# SERVICE BULLETIN

## NO. A3312-71-1

POWER PLANT-FAN COWL-HOLD OPEN ROD  
REPLACE OUTER TUBE RIVETS

FIGURE 1 — OUTER TUBE AND END CAP

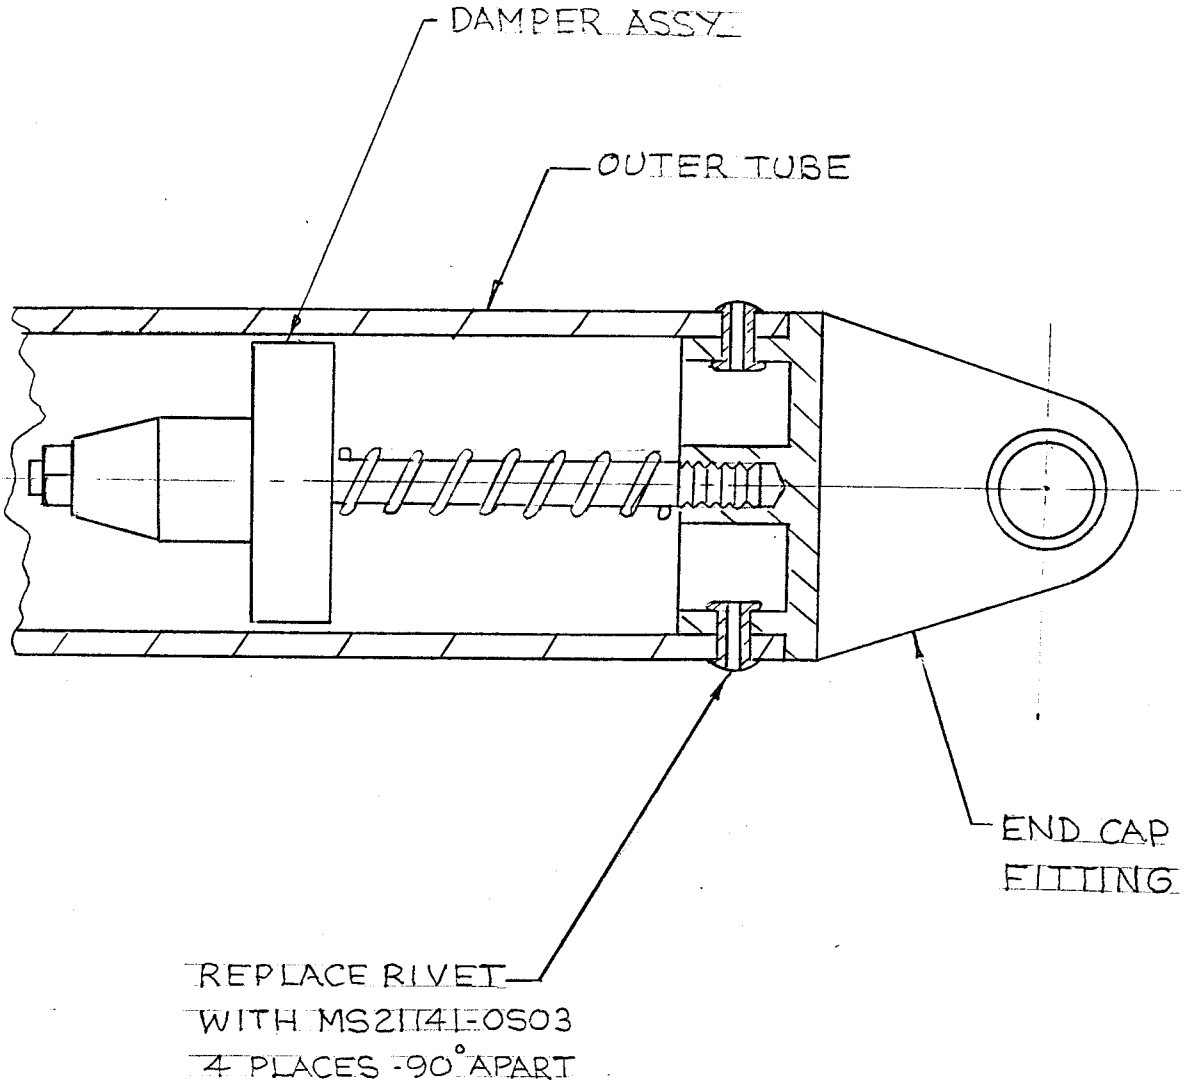
This service bulletin provides detailed instructions required for all users to rework Norco P/N A3312-1, Rohr P/N 277D1250-501. The rework consists of removing the four (4) rivets in the rear end of the outer tube and replacing them with four (4) higher strength rivets.

- A. Drill out four (4) rivets in outer tube, shown in Figure 1, using a No. 19 drill (.166 inch diameter).
- B. Place a mark on the outer tube and end cap to indicate alignment of the four holes. Remove end cap assembly from the outer tube.

- E. Install four (4) MS21141-0503 rivets using a double action tool as indicated on sheet 1 of the attached Military Standard MS21141.
- F. Clean area immediately following NORCO P/N A3312-1 by rubbing with wiper damped with Aliphatic Naphtha, TT-N-95, or equivalent, until soil is removed. Do not allow solvent to evaporate. Avoid removing pretreatment or finish coating. After soil is removed, wipe the area dry with a clean dry wiper. Using rubber stamp letter size 1/8" to 3/16" and Alcosol or F-100 stamp pad ink, or equivalent, apply the letter "M" immediately following the dash number "-1". Clean stamp with naphtha, or equivalent, as required, for mark legibility and sharpness. Allow ink to dry at least ten minutes and overcoat with Bostik 683-3-2 or 683-3-9 or equivalent.
